**CONEWANGO CREEK WATERSHED
DAM No. 9A**

**CHAUTAUQUA COUNTY, NEW YORK
INVENTORY No. N.Y. 596**

**PHASE I INSPECTION REPORT
NATIONAL DAM SAFETY PROGRAM**

**CONEWANGO CREEK WATERSHED PROJECT
SITE 9A
FLOODWATER RETARDING DAM
CHAUTAUQUA COUNTY, NEW YORK
FILL PLACEMENT & PRINCIPAL SPWY EXCAVA
U. S. DEPARTMENT OF AGRICULTURE
SOIL CONSERVATION SERVICE**

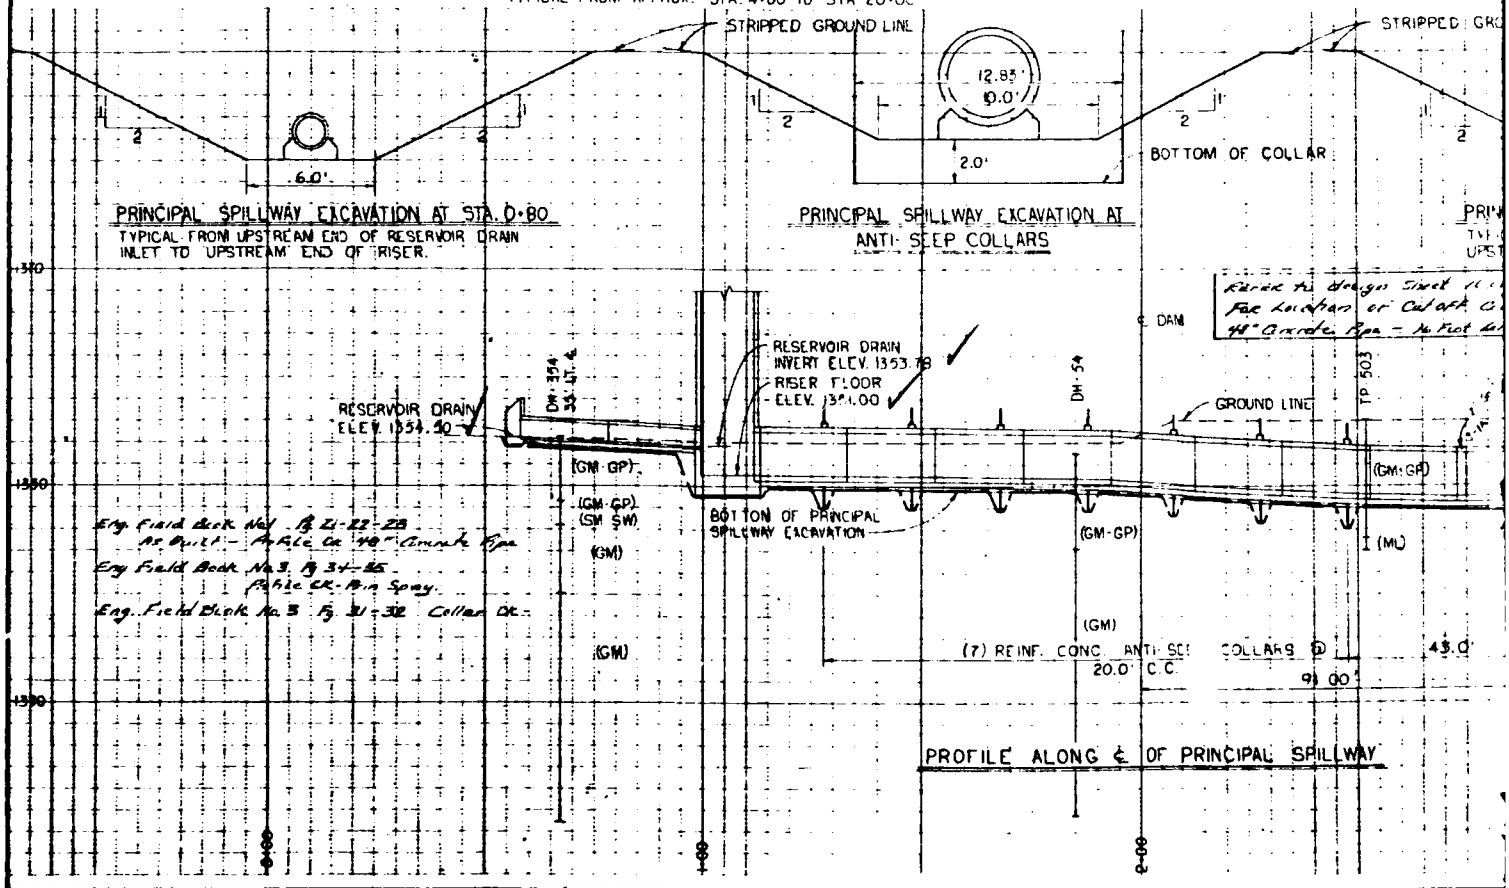
1. On sheet No. 7, Drawing No. NY-2161-P under Earth Fill Requirements Note No. 2, "hand tamping or" should be deleted.
